Work Order ID 106076

Item Name: Aft Crosstube - High

DRAWING NO. D412-664-243	TITLE CROSSTUBE ASS'Y (412 HI AFT)	REV. E	DART AEROSPACE LTD ENGINEERING ORDER		D.E.O. NO. D412-664-243-E-2	SHEET NO. SHEET 1 OF 1	SCALE NTS
DRAWN MP	CHECKED ASS	MFG. APPR. E	APPROVED MP		DE APPR. #		
DATE 11.09.07	DATE 11.09.19	DATE 11.09.19	DATE 11.09.19		DATE 11.09.19

SECTION A-A
CHAFING SHIELD DETAIL
VIEW ROTATED, NOT TO SCALE

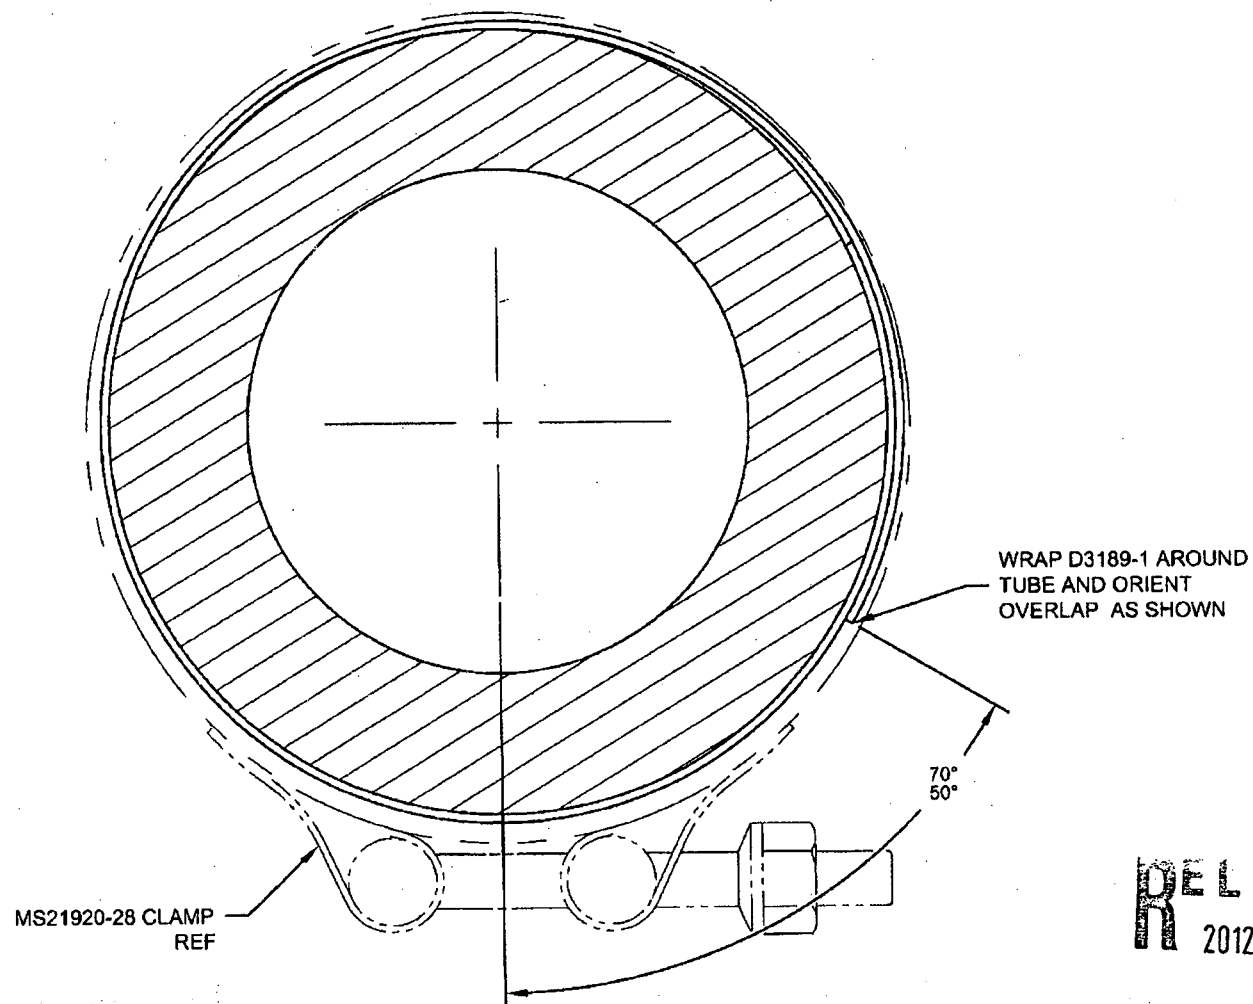
NOTES 2, 14, AND 16 ON SHEET 1 ARE AMENDED AS FOLLOWS:
